ADDENDUM NO. 3

BEACHCREST WELLFIELD IMPROVEMENTS

LACEY CONTRACT NO. PW 2019-29

Issued this 19th day of December 2022.

SECTION
A
M-2
SCALE: 3/8"=1'-0"

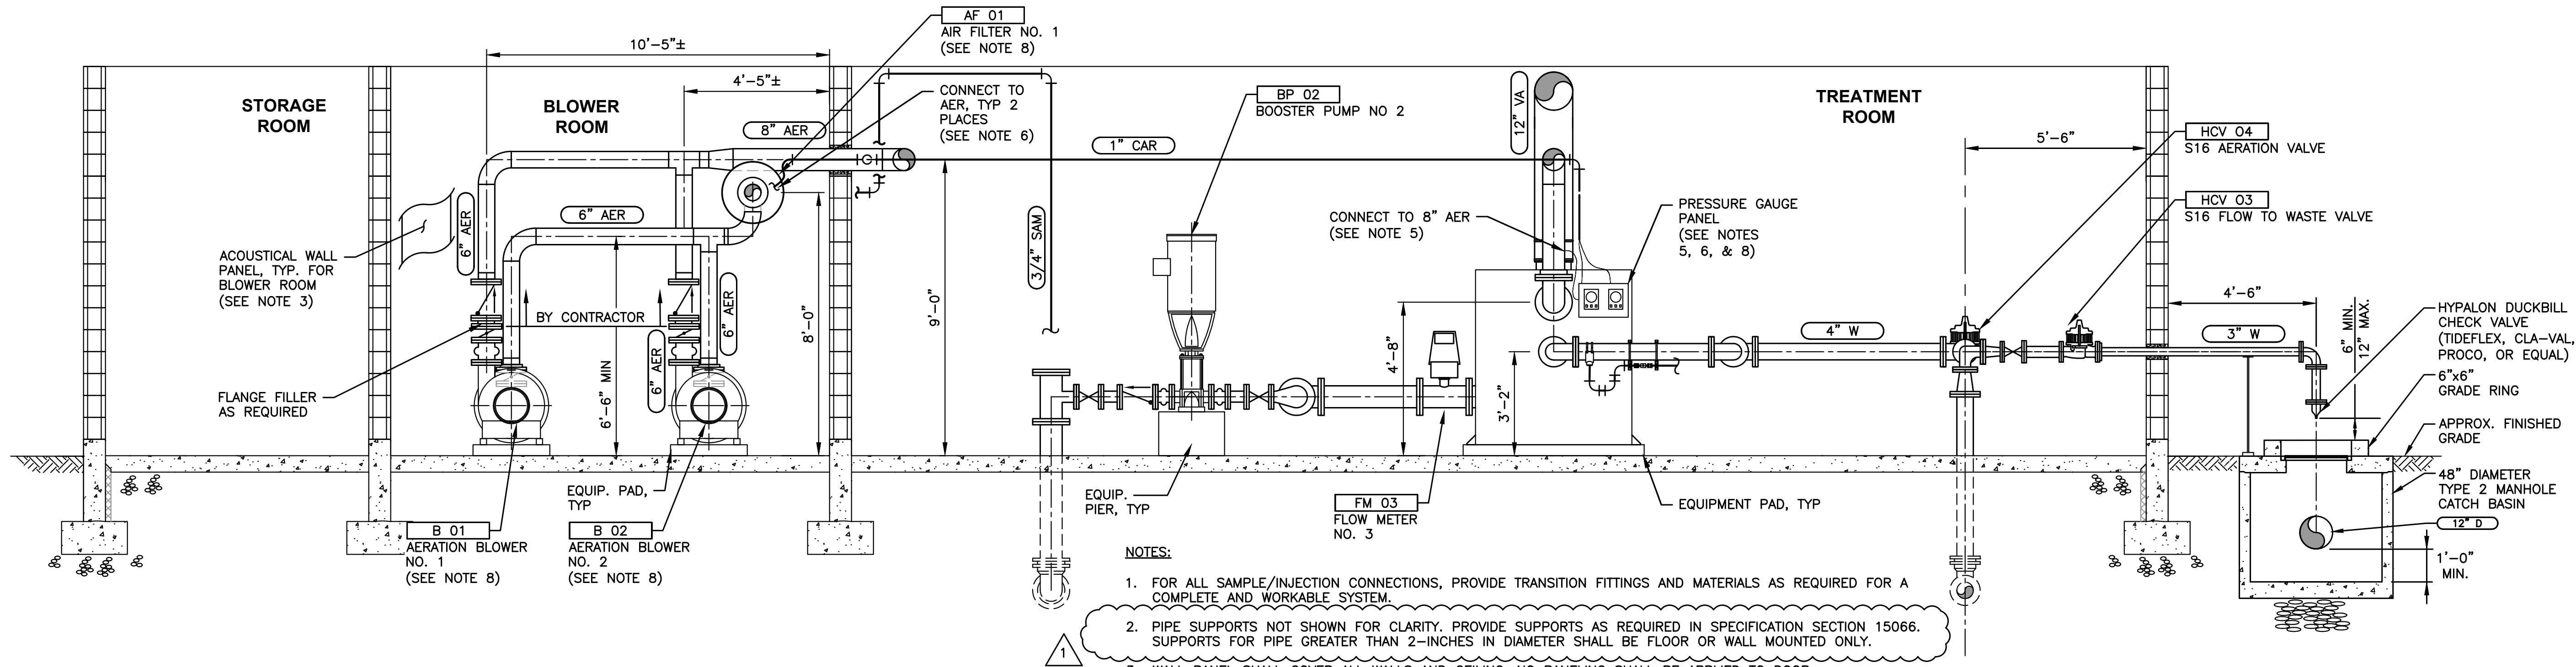
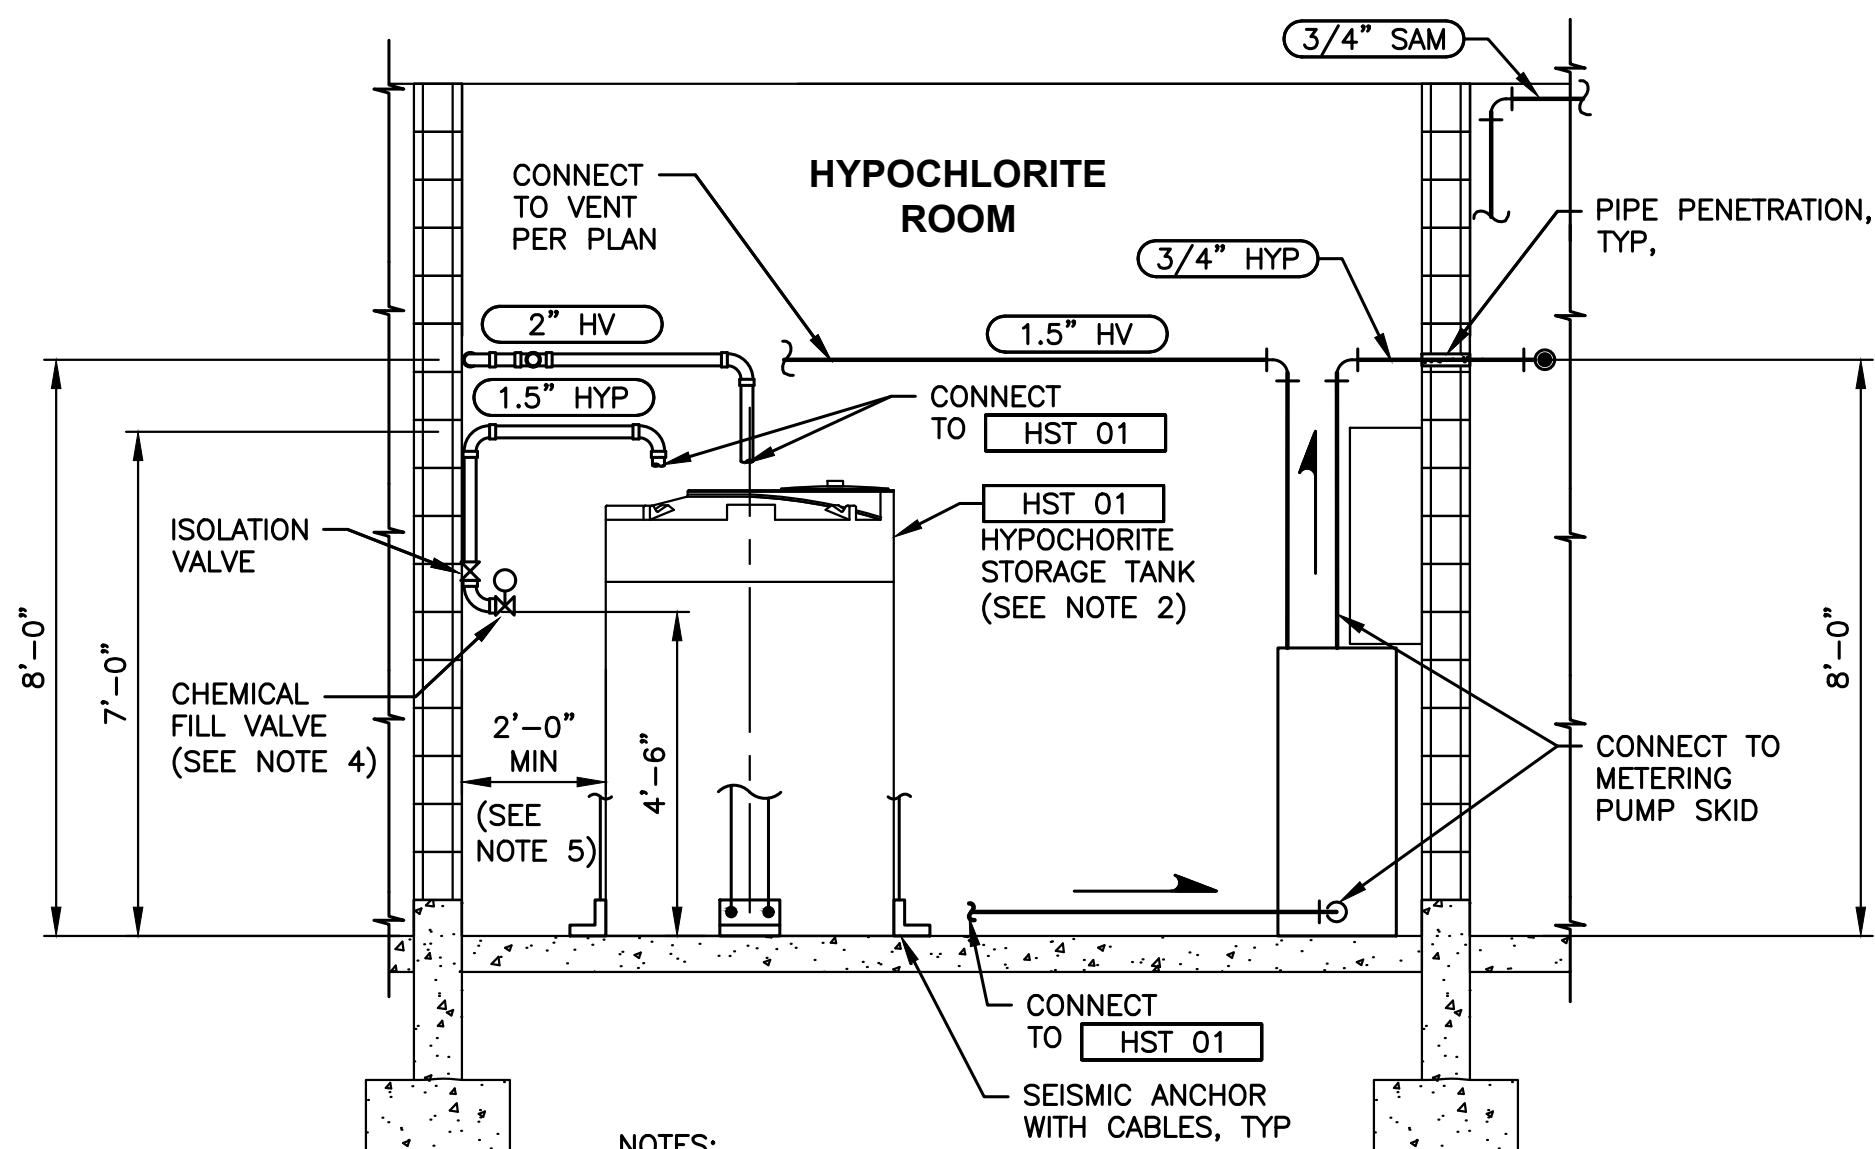
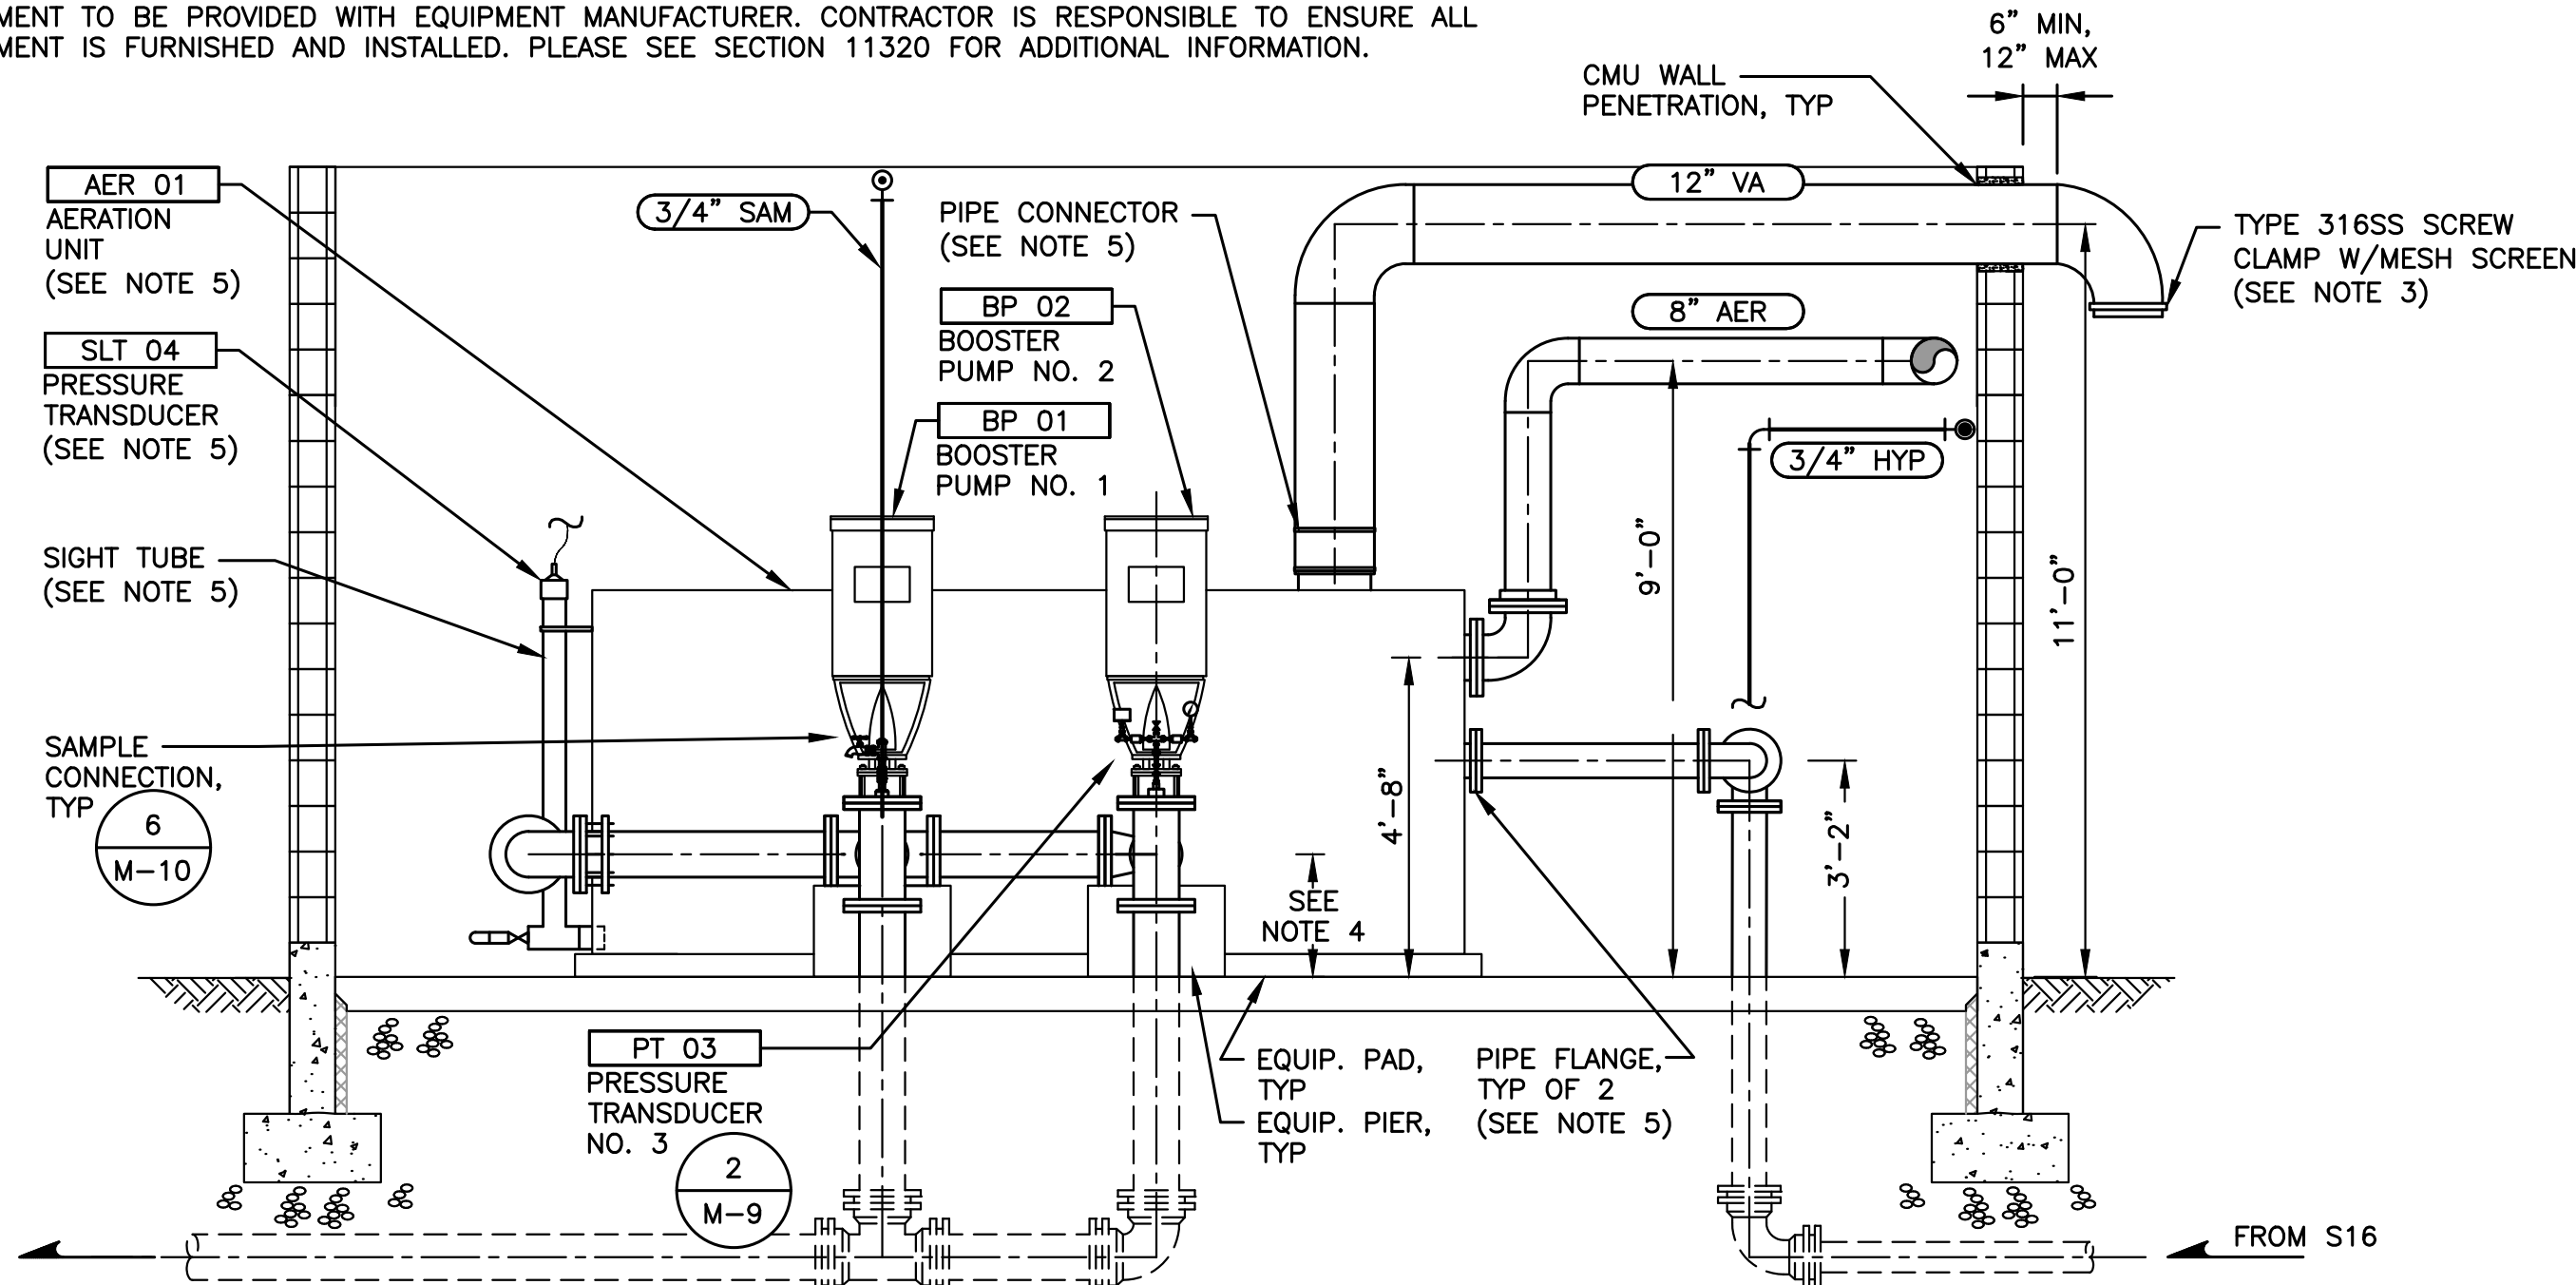
ITEM NO. 20:
Sheet M-2

2) *The revisions include modifications to the Notes on Sheet M-2.*

Delete Sheet M-2 and replace it with the new page as attached.
